CITY OF FRESNO – ADDENDUM NO. 2

RIVER WEST FRESNO EATON TRAIL EXTENSION, PHASE 1

BID FILE NUMBER: 12700455

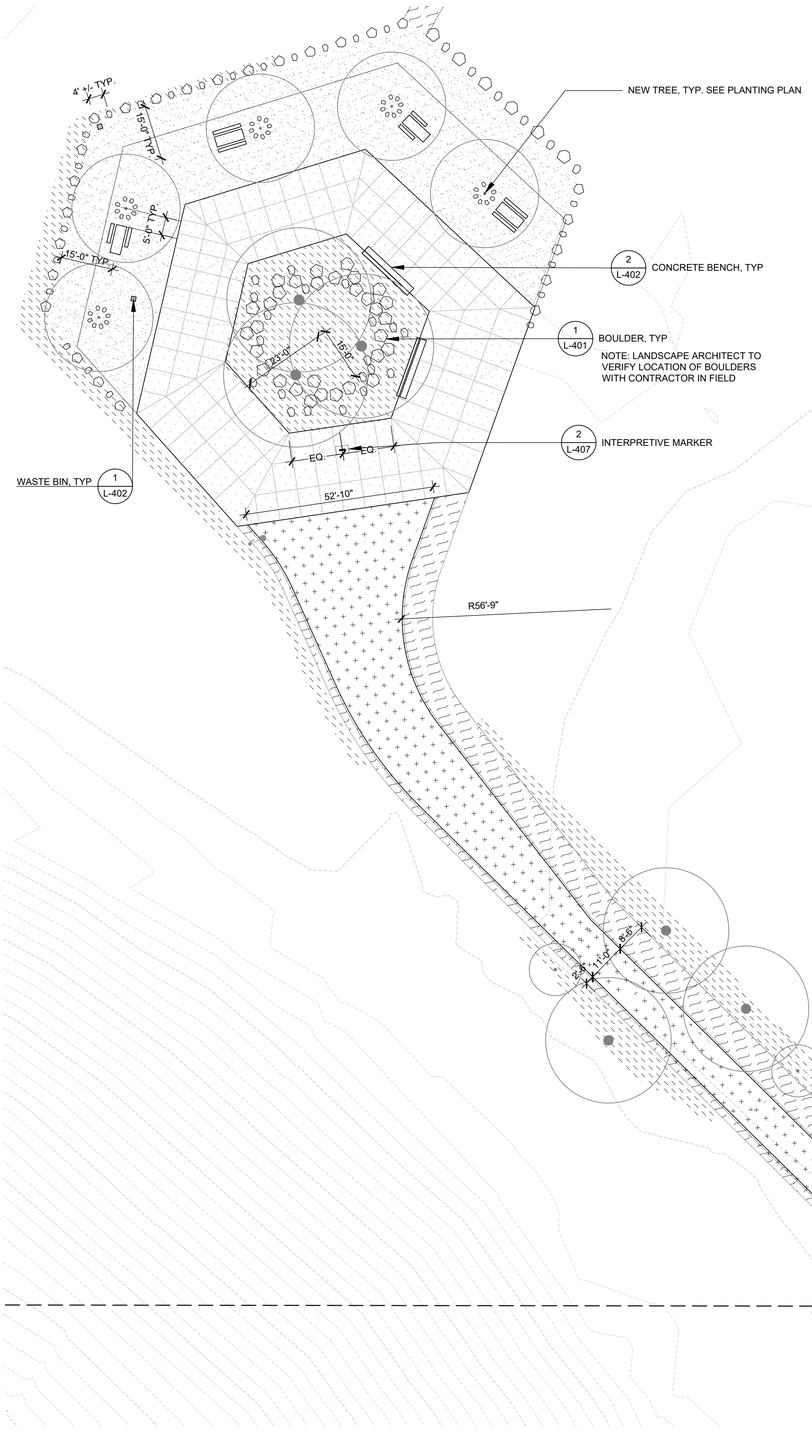
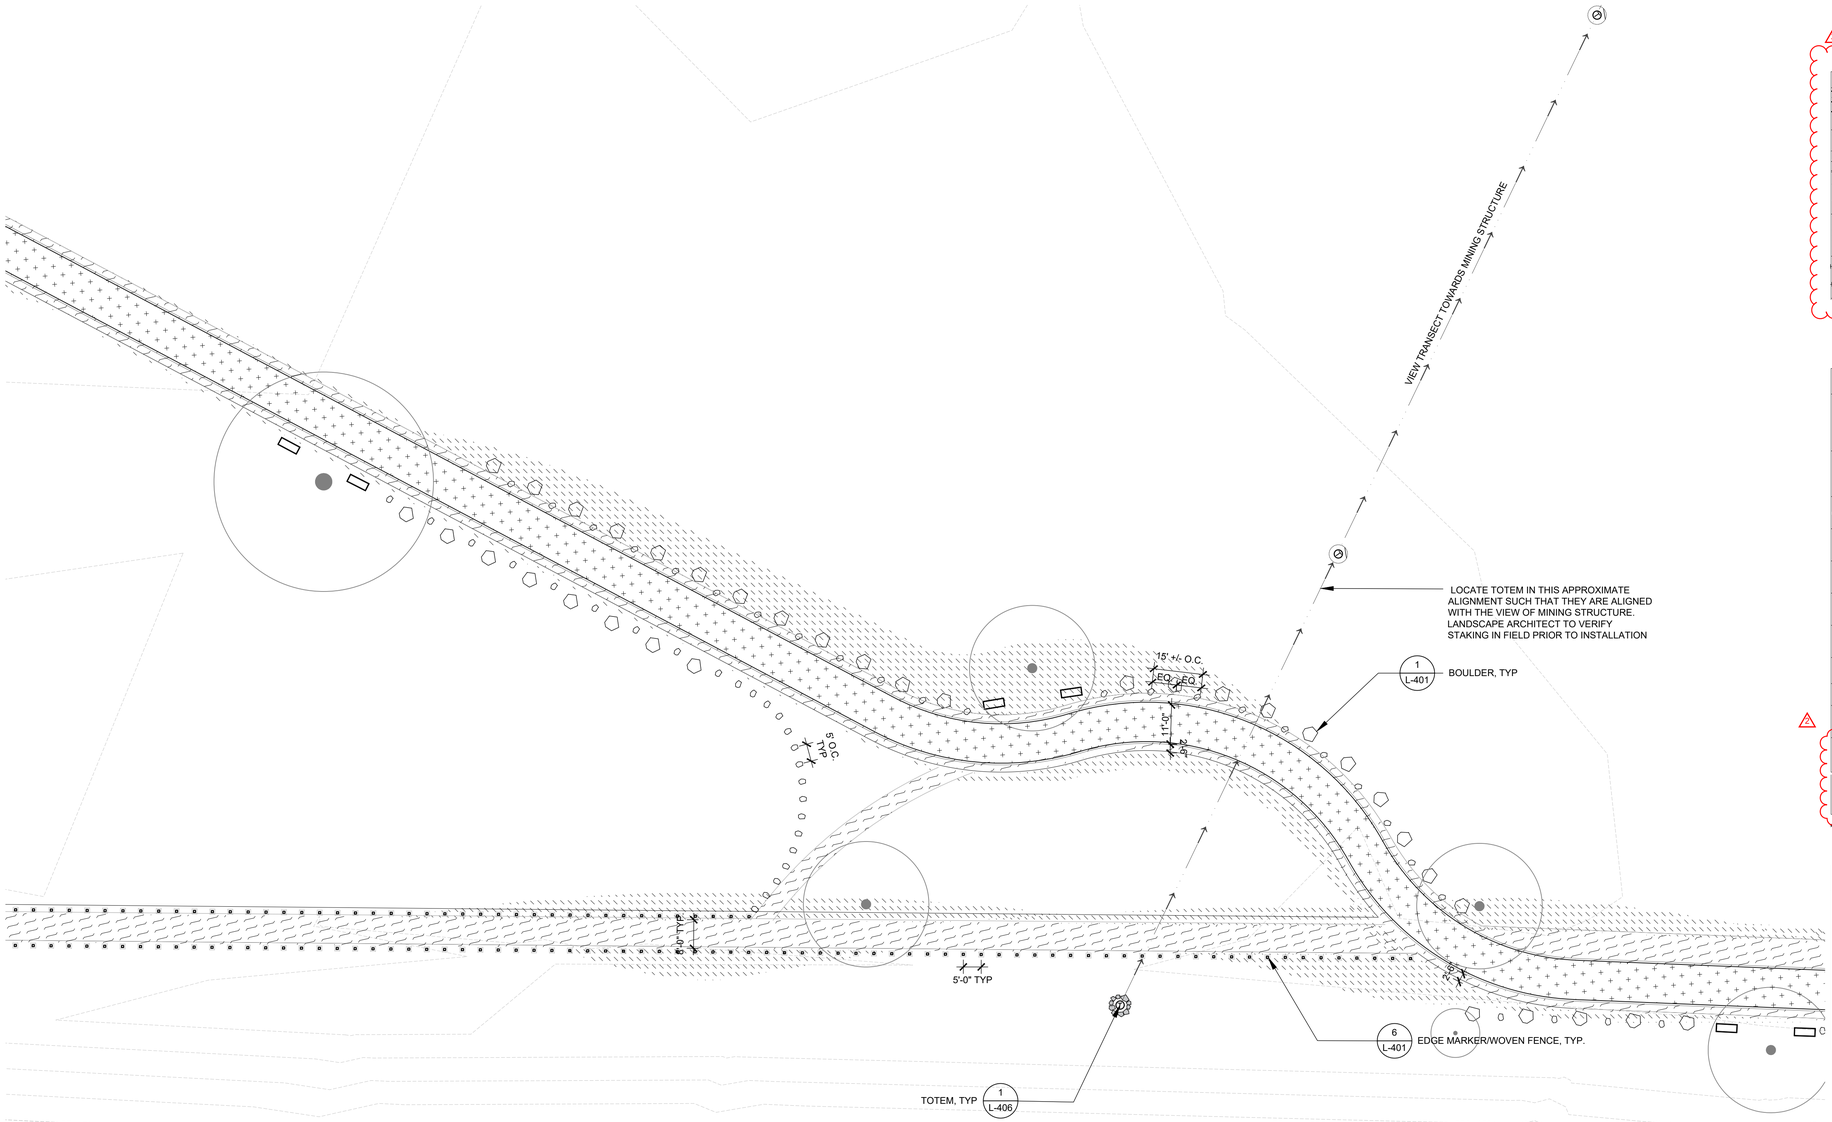
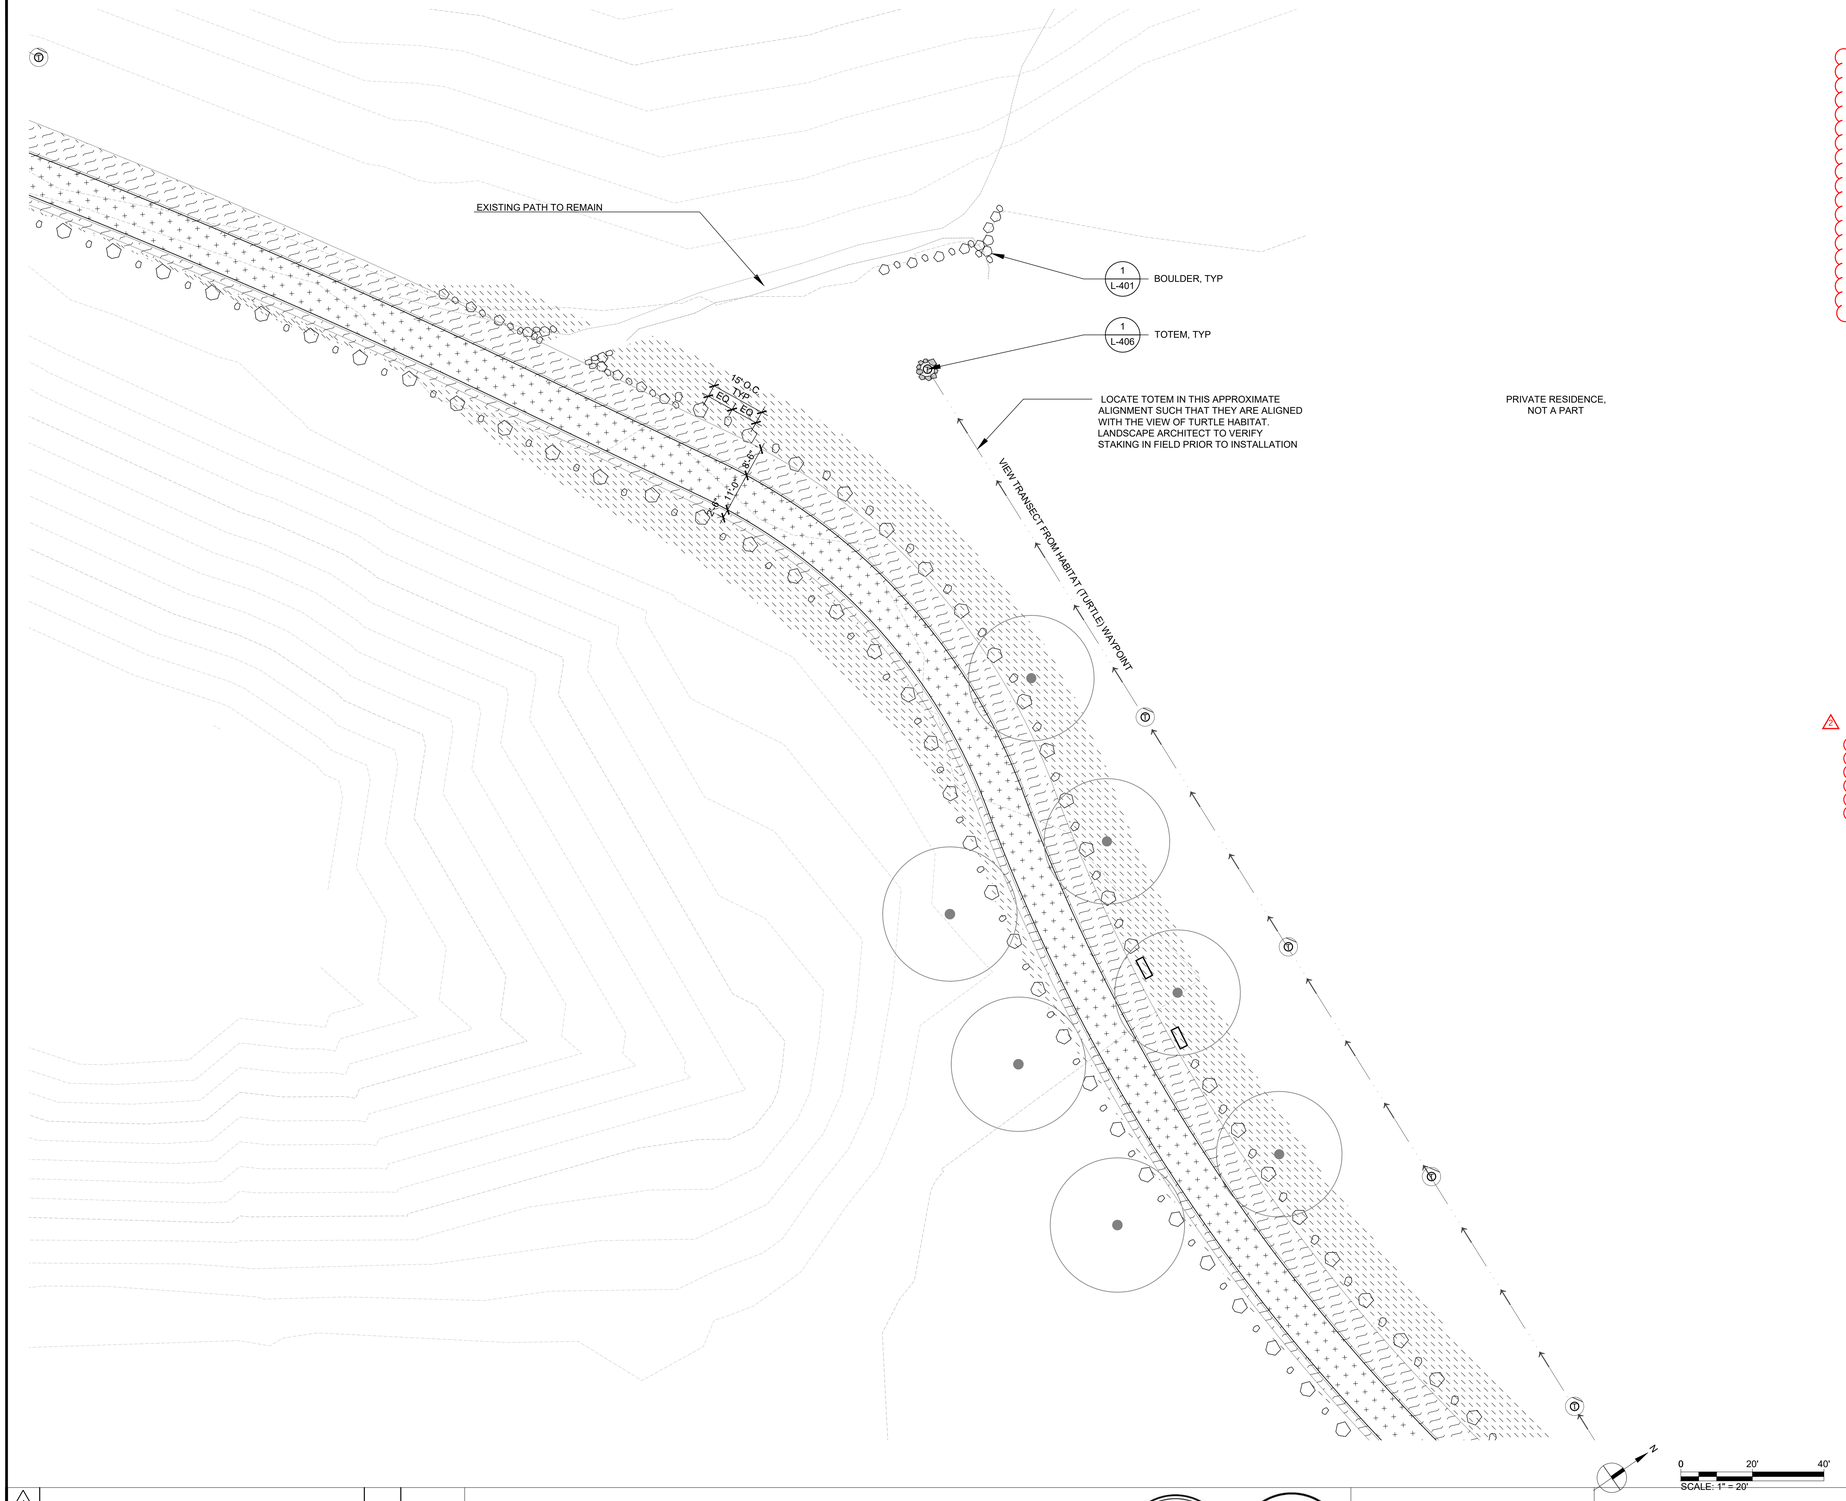
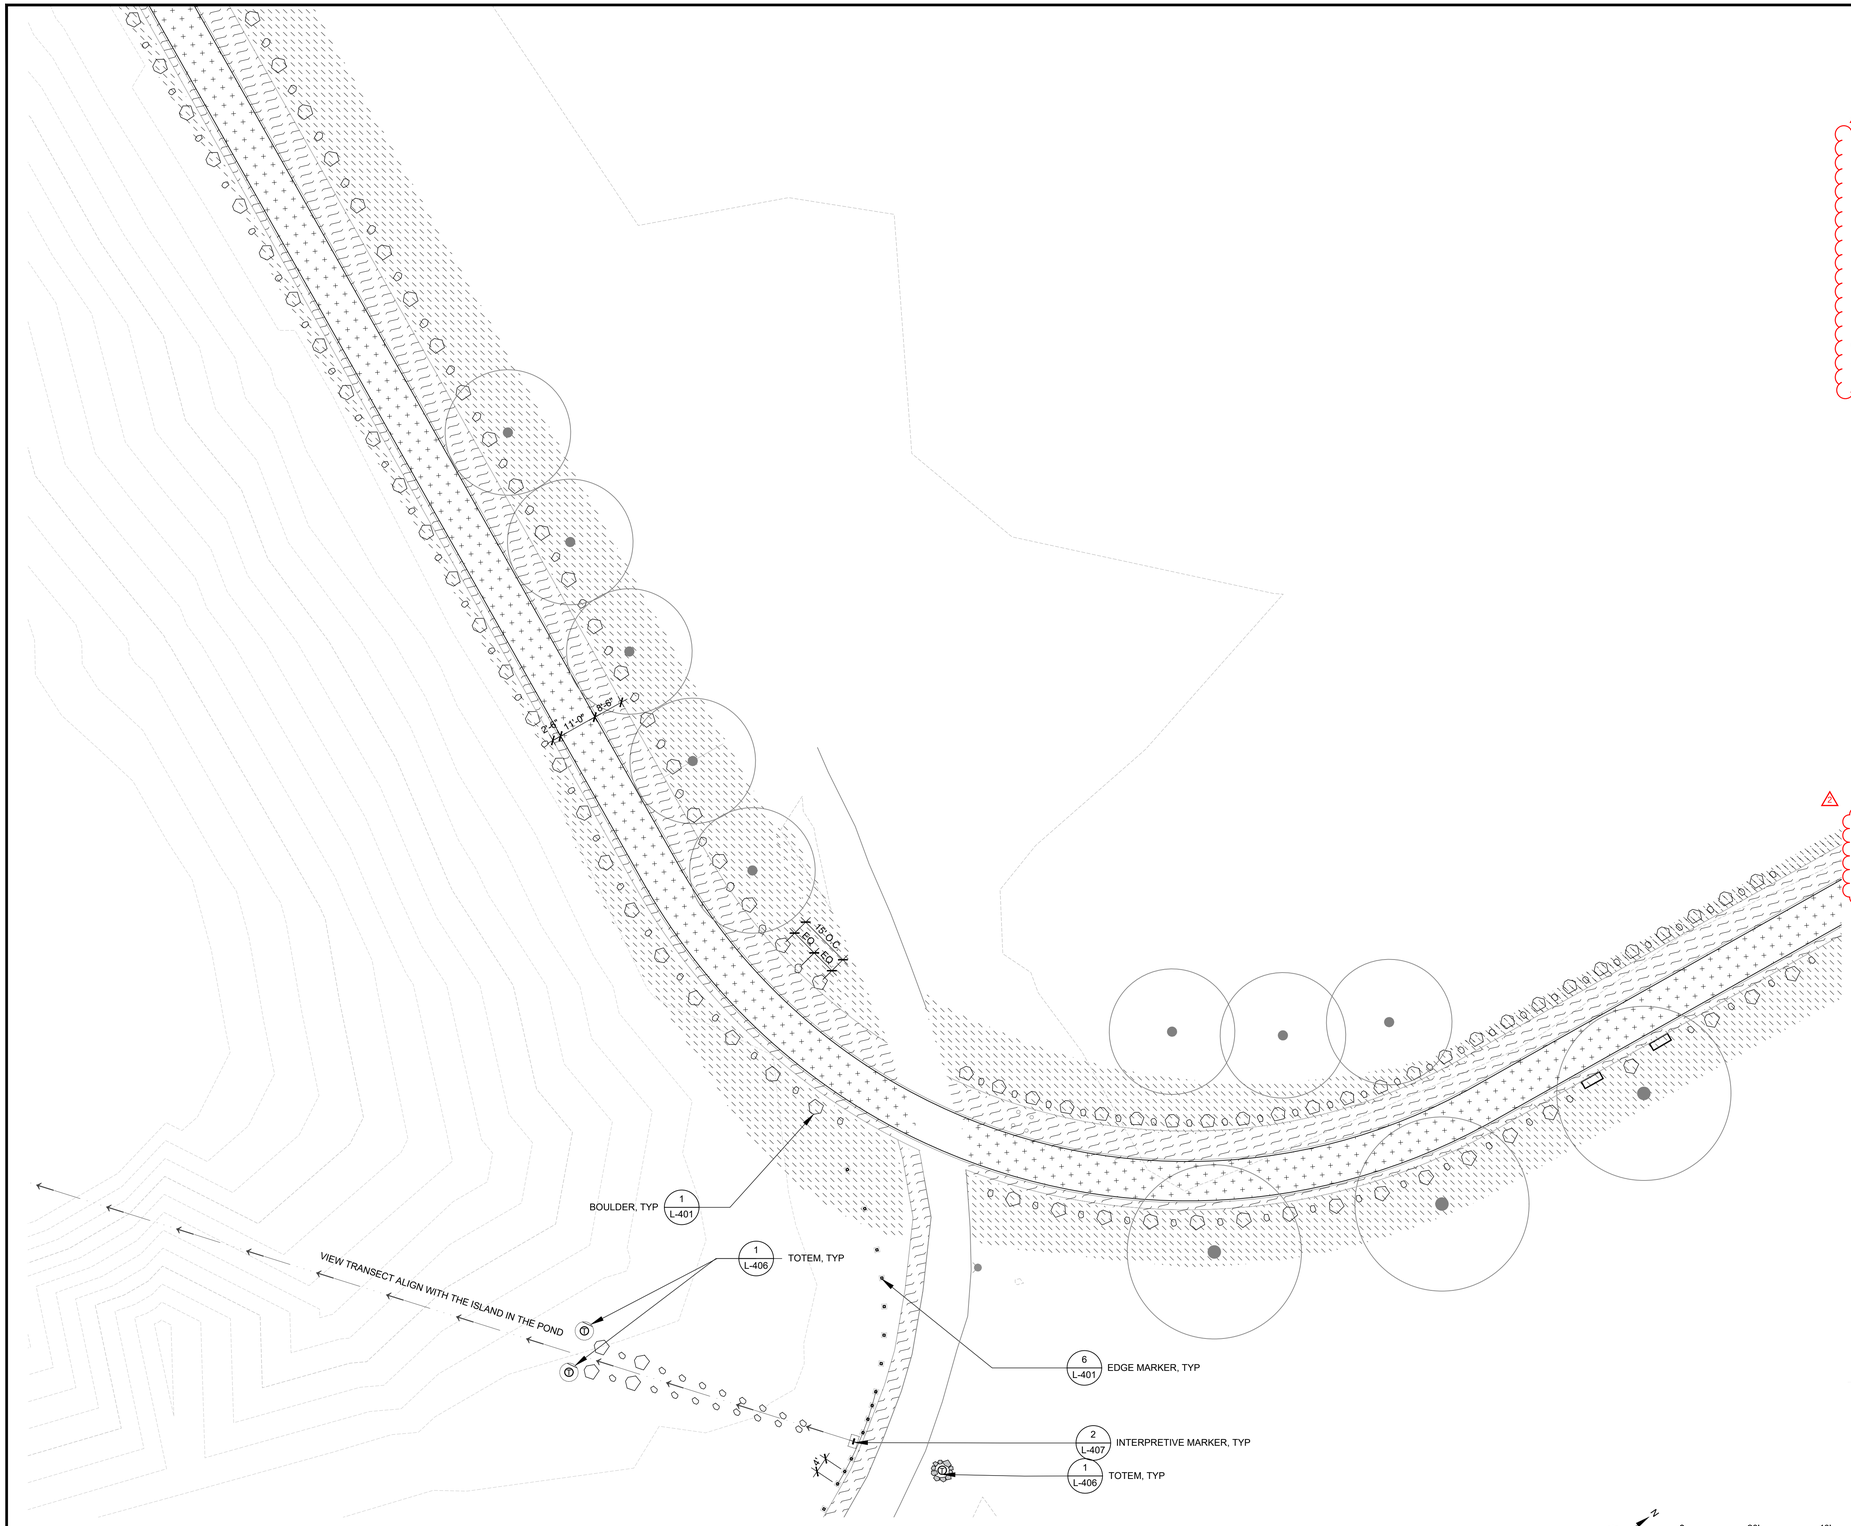
Paving legend on sheets L101 through L110 show gravel tuscany gold in the legend, but the plans don't show the locations of the gravel? Please show the locations of the gravel so the contractor may know where its being installed.

How will the three cast-in-place circular concrete benches shown on plan sheet L-109 be measured and paid for?

The Landscape Plan Sheet Legend shows the Edge Markers with as a quantity of 256 each. Our takeoff counted 527 each. Please review and revise the quantity as necessary.

9. Modification to irrigation connections on Sheet No. 15-E-14657 to Sheet 15-E-14666:

- Remove and Replace Sheet No. 15-E-14657 to Sheet No. 15-E-14666, Sheet 76 to 85 of 133, entirely with Addendum No. 2 Drawing Sheet No. 15-E-14657 (Addendum No.2) to 15-E-14666 (Addendum No.2), (clouded and marked ADDENDUM NO. 2) which modifies the following:
  - Updates paving table to remove gravel.
  - Clarifies the number of circular concrete benches.
  - Clarifies the number of edge markers.

See updated Sheets 76 to 85 of 133, Drawing Sheet No. 15-E-14657 (Addendum No.2) to 15-E-14666 (Addendum No.2), which updates paving table to remove gravel.

There is a total of 100 LF of circular concrete bench. See updated Sheets 76 to 85 of 133, Drawing Sheet No. 15-E-14657 (Addendum No.2) to 15-E-14666 (Addendum No.2), which clarifies the number of circular concrete benches. See updated Specifications Division VI Technical Specifications page 6.12 (Addendum No. 2) Bid Item Description for Bid Item 29 – Site Furnishings.

There is a total of 527 Edge Markers. See updated Sheets 76 to 85 of 133, Drawing Sheet No. 15-E-14657 (Addendum No.2) to 15-E-14666 (Addendum No.2), which clarifies the number of Edge Markers. See updated Specifications Division VI Technical Specifications page 6.12 (Addendum No. 2) Bid Item Description for Bid Item 29 – Site Furnishings.
